Control of Air Pollution from Motor Vehicles: Tier 3 Motor Vehicle Emission and Fuel Standards

Summary and Analysis of Comments

Assessment and Standards Division
Office of Transportation and Air Quality
U.S. Environmental Protection Agency

Figure 6-3
NPRM MOVES NLEV (Passenger Car) Sulfur Impact
Running Exhaust NOx, Normal Emitter

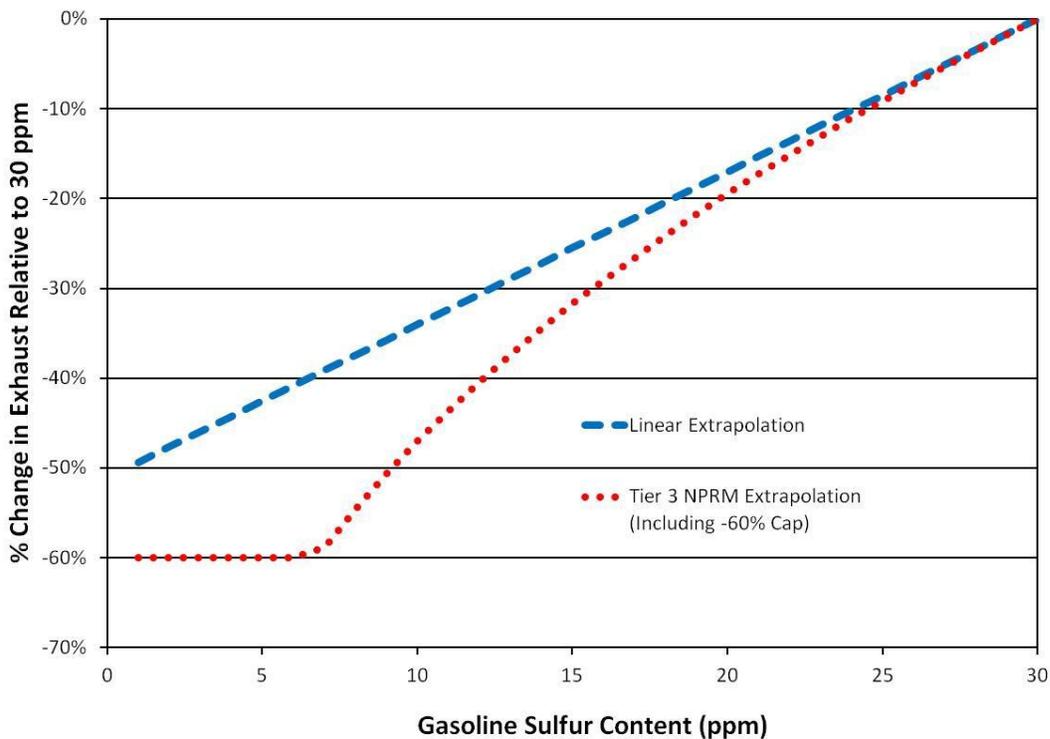
NPRM MOVES incorporated no new data for estimating 2003 and older model year vehicle fuel sulfur impacts. In order to evaluate fuel sulfur levels at or below 10 ppm as part of the regulatory evaluation, the model simply extrapolates preexisting sulfur adjustment equations present in the public version of MOVES. Thereby, the NPRM MOVES model methods are that of MOVES2010a with one minor change. Because this sulfur correction is an extrapolation (most of the underlying methods developed did not contain any fuels below 30 ppm S, see Table 6-5), EPA programmed in a cap at the maximum allowable exhaust reduction due to sulfur below 30 ppm. In MOVES2010a that cap is 15 percent (defined relative to 30

ppm fuel); in NPRM MOVES that cap is 60 percent (defined relative to 30 ppm fuel).⁷² EPA’s justification is that the in-use sulfur test program with Tier 2 vehicles showed reductions up to 60 percent; therefore, greater reductions should be permissible when extrapolating previous test programs beyond the lower sulfur limit tested.

Figure 6-3 presents an example of how the linear extrapolation compares to that used by NPRM MOVES for NOx emissions from normal emitting NLEVs (passenger cars).

In modeling the emissions impact from the proposed rule, we did not attempt to update the fuel sulfur algorithm in MOVES for the pre-2004 model year vehicles because we were not aware of any additional data that provided information on fuel sulfur below 30 ppm for the legacy vehicles. Therefore, the commenter is correct that the effects of sulfur for pre-2004 model year vehicles are based on extrapolation.

However, the commenter did not accurately characterize the effect of extrapolation in the plot they presented above. Figure 3-10 through Figure 3-13 show the effect of sulfur on running exhaust emissions from pre-2004 model year vehicles for sulfur levels below 30 ppm, based on MOVES. The red lines represent the old sulfur floor of 15 percent, previously in MOVES2010a, and the blue lines represent the new sulfur floor of 60 percent in Tier 3 NPRM version of MOVES. For all pollutants, the lines lie on top of each other for sulfur level at or above 10 ppm, the average in-use sulfur level modeled in the Tier 3 rule. The two lines start to diverge only below 10 ppm. These trends are also true for the sulfur effects on starts. The plots indicate that the modification made to the sulfur floor in the Tier 3 NPRM version of MOVES did not affect the sulfur adjustment and thus, did not impact the emissions inventories estimated in the rule.

Figure 1. Cold-start NOx results for the EPAct Phase-3 Program, averaged by Aromatics Level (vol.%) and by Vehicle.

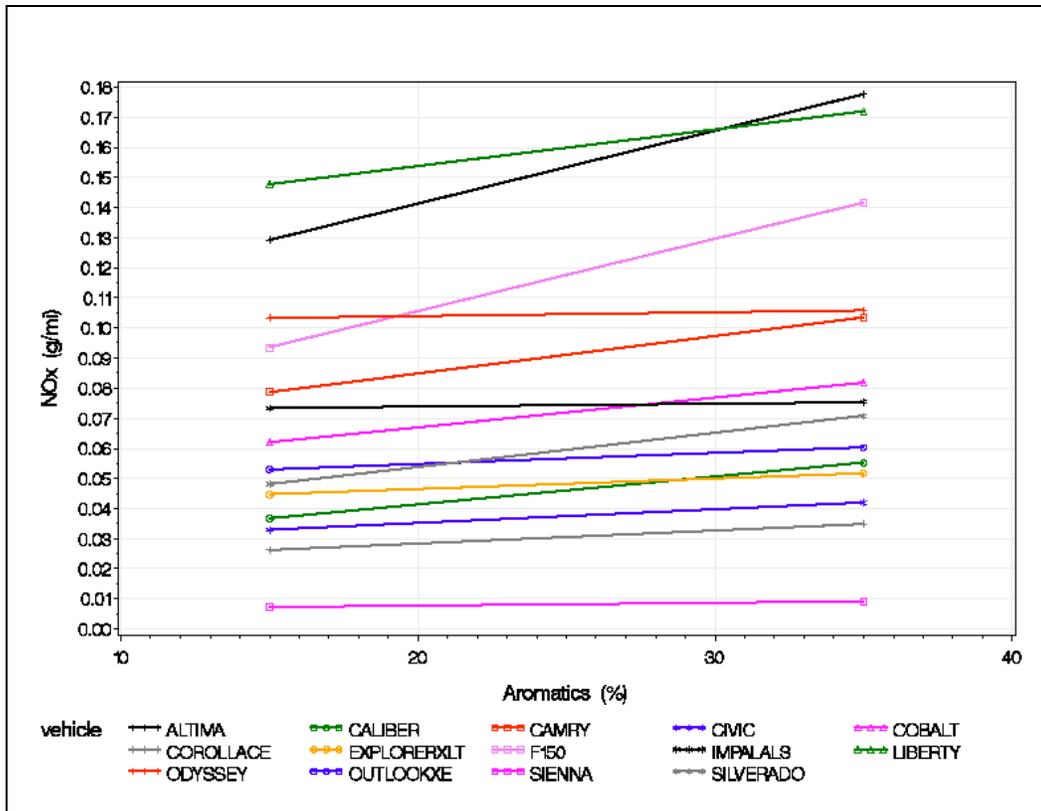
In addition, in contrast to most studies, the design for the EPAct study is well balanced between the two aromatics levels studied and the levels of the four remaining properties. When the results are averaged by vehicle and by fuel properties, the results suggest a notable increase in NO_x for most vehicles, as shown in the figures below. For example, in Figure 1, which shows cold-start (Bag 1) NO_x results averaged by vehicle and aromatics level, 13 of 15 vehicles show higher NO_x at the higher aromatics level, with the remaining two vehicles showing no obvious change. This effect is also clearly visible when the results are averaged by the two aromatics levels and the levels of any of the four remaining fuel properties. Results are similar but not identical for hot-running (Bag 2) results shown in Figure 2. For running emissions, behavior by vehicle is more complex, with six of the vehicles showing a decline or no change by aromatics

level, but with the remaining vehicles showing increases. While this set of results suggests an increase in NOx on average, it also shows variability in vehicle responses, which may be attributable in some degree to measurement or random error, or also to differences in vehicle design, calibration or emission-control strategies.
